# Access Compliance Report

## Public Rights-of-Way

Intersection ID: 49138	Main Street: CLARKE RIDGE CT	Cross Street: AMBER LEIGH WAY DR	Location: SE
ADA ID: 86836A12DB7E	Ramp Type: PerpDiag	Initial Pass/Fail: Fail	Overall Compliance: No
Codes/Mitigation Info/Possible Solution			Severity Score: 10
			Field Measurements/Component Compliance

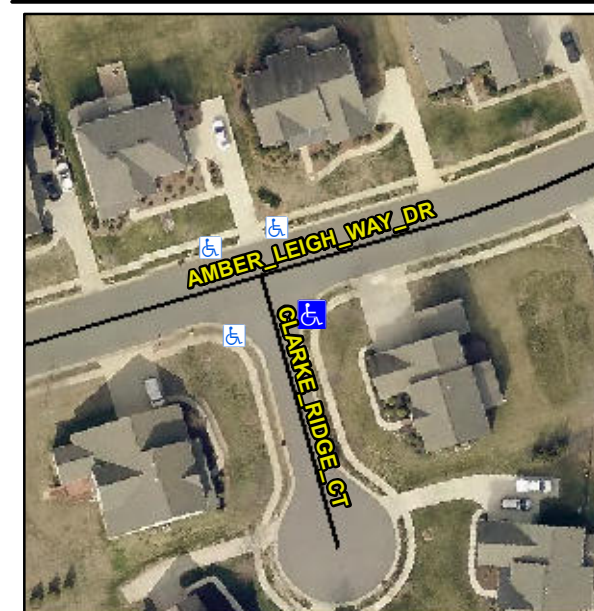
**Not Found, R304.5.1, R304.5.3**

Compliance	Description	Data	Compliance	Description	Data
N/A	Ramp Length (in)	48.0	Yes	Ramp Slope (%)	6.9
No	Ramp Width (in)	47.5	No	Ramp XSlope (%)	3.6
N/A	Flare Type LT	N/A	N/A	Flare Type RT	N/A
N/A	Flare Slope LT (%)	N/A	N/A	Flare Slope RT (%)	N/A
N/A	Flare Traversable LT?	N/A	N/A	Flare Traversable RT?	N/A
N/A	Landing Length (in)	N/A	N/A	DWS Provided?	N/A
N/A	Landing Width (in)	N/A	N/A	DWS Contrast?	N/A
N/A	Landing Slope (%)	N/A	N/A	DWS Length (in)	N/A
N/A	Landing X Slope (%)	N/A	N/A	DWS Full Width?	N/A
N/A	Landing Curb? (Y/N)	N/A	N/A	DWS Offset (in)	N/A
N/A	Shared Landing?	N/A			
N/A	Gutter Ponding?	N/A	N/A	Gutter Slope (%)	N/A
N/A	Gutter Lip Ht (in)	N/A	N/A	Gutter X Slope (%)	N/A
N/A	Painted X Walk1?	No	N/A	Painted X Walk2?	No
	X Walk 1 Direction	To N		X Walk 2 Direction	To W
N/A	X Walk 1 Width (in)	N/A	N/A	X Walk 2 Width (in)	N/A
	X Walk 1 Slope (%)	6.9		X Walk 2 Slope (%)	1.2
	X Walk 1 X Slope (%)	3.1		X Walk 2 X Slope (%)	6.3

**Remove & Replace Curb Ramp With Two New Directional Ramps or Equivalent.**
